**Car Stereo
Service Bulletin**

Model: XR-U880

No. 228

Subject: Low Contrast On LCD Display

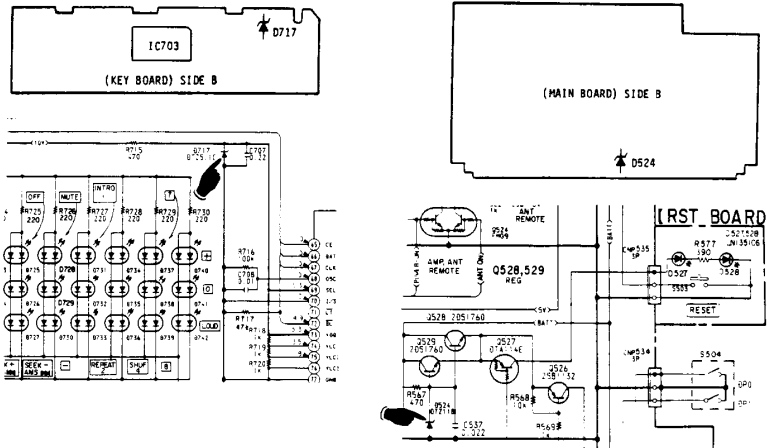
Symptom:
(13) The LCD display has low contrast.

Solution: Perform the following modifications on the Main MCB and the Key MCB:

1. Change D-717 on the Key MCB from DTZ5.1C to DTZ6.2B.
2. Change D-524 on the Main MCB from DTZ11B to RD12ESB2.

REF	FORMER		NEW	
	DESCRIPTION	PART NUMBER	DESCRIPTION	PART NUMBER
D-717	DTZ5.1C	8-719-977-00	DTZ6.2B	8-719-977-07
D-524	DTZ11B	8-719-977-32	RD12ESB2	8-719-110-31
